**New dual occupancy (attached), swimming pool and Torrens title subdivision of proposed Lot 1 under LDA2021/0148: Section 4.55(2) Modification Application (LDA2021/0362)**

6 & 10 Clermont Avenue, Ryde

Statement of Environmental Effects to  
City of Ryde Council

4 July 2022 | 20097

Figure 1 – Proposed Basement Floor Plan (Source: Drawing 782DA\_A\_04 Revision E, by Studio\_BD)

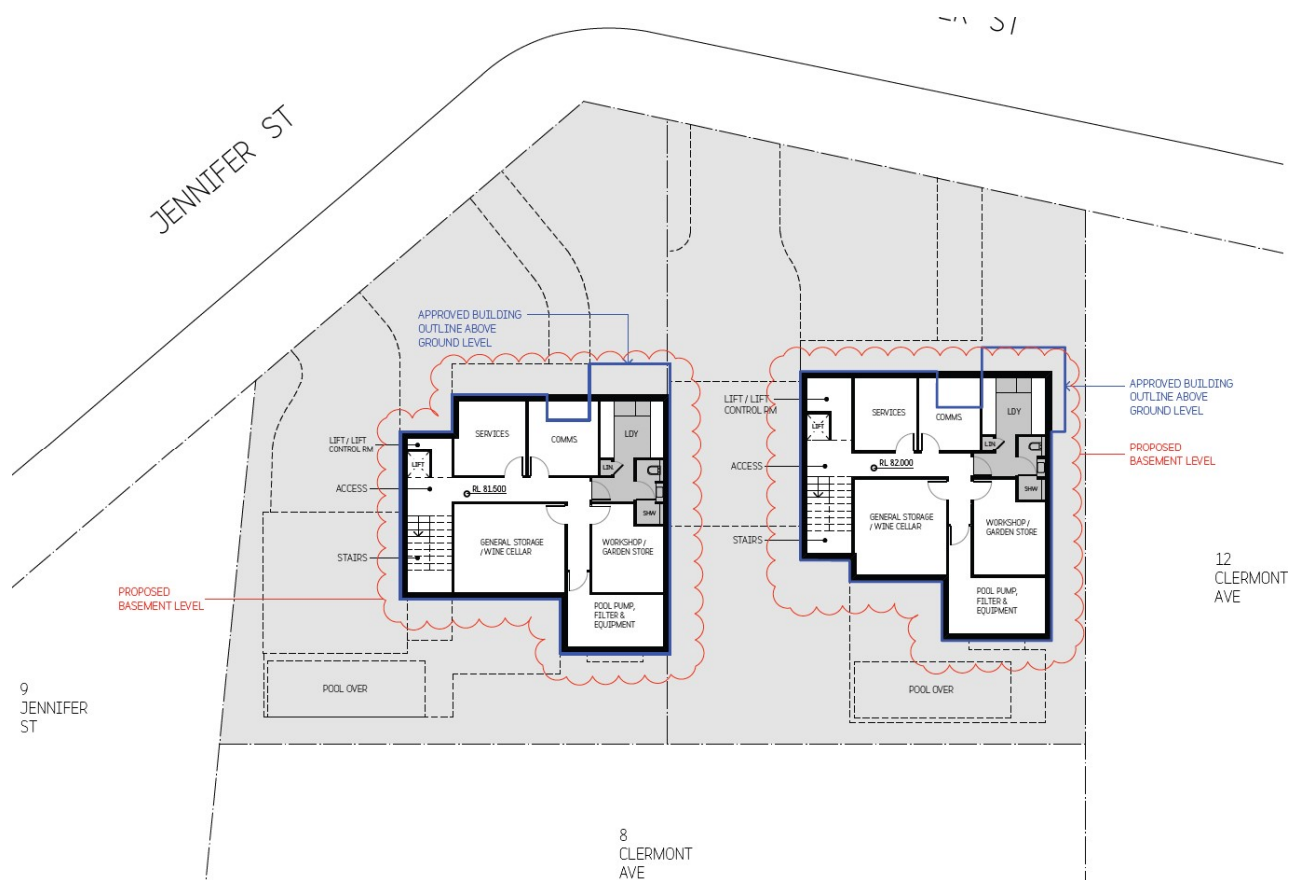
1. Minor changes to the *dual occupancy (attached)* building comprising the following:
  - (a) New basement level accommodating storage, plant/equipment and laundry
  - (b) Extension of lift to new basement to promote aging in place
  - (c) Minor changes to the First Floor Plan and Roof Plan including:
    - (i) Glass blocks to windows W19, W20 & W22.
    - (ii) New skylight to Bedroom 2 (for ventilation).
    - (iii) Window W21 min 900mm from boundary to comply with BCA without providing glass block windows.

**Figures 1 to 3** show extracts from the approved and modified Architectural Plans (the modified plans show changes in red cloud). The proposed changes to the conditions are described at Section 3.3.

Figure 2 – Comparison of approved and proposed Section A-A (Source: Studio\_BD)

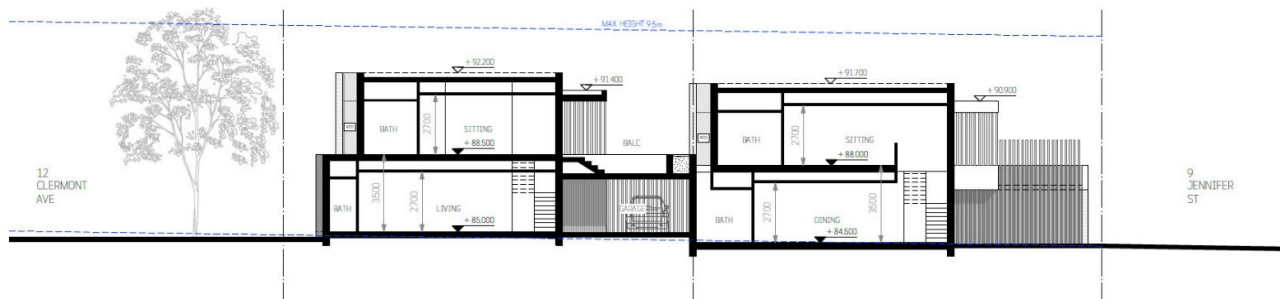
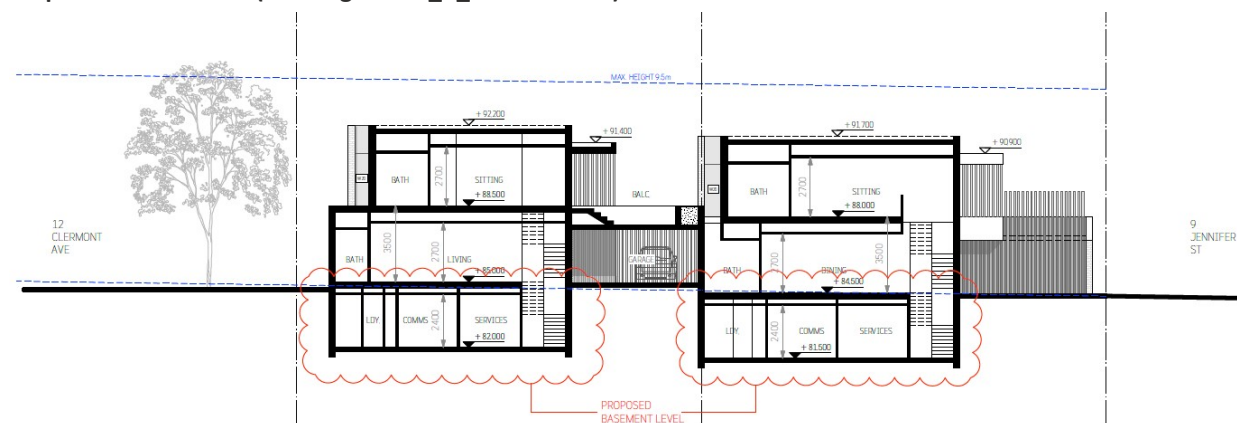
Approved (Drawing 782DA\_A\_09 Revision C)

Proposed modification (Drawing 782DA\_A\_09 Revision D)

**Figure 3 – Comparison of approved and proposed North Elevation to Jennifer Street – NO CHANGE** (Source: Studio\_BD)

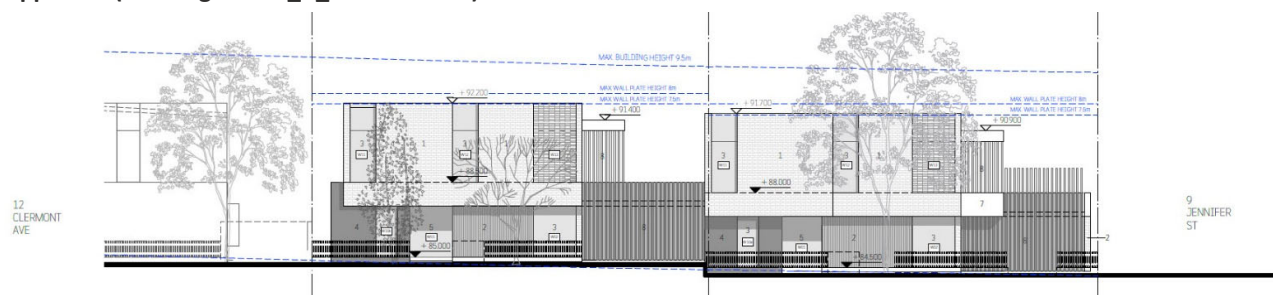
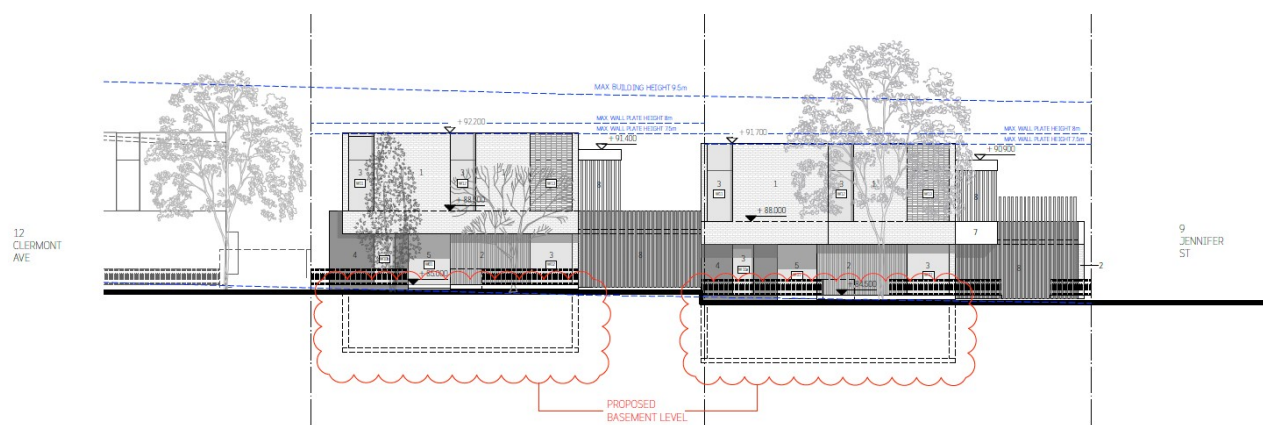
Approved (Drawing 782DA\_A\_11 Revision D)

Proposed modification (Drawing 782DA\_A\_11 Revision E)
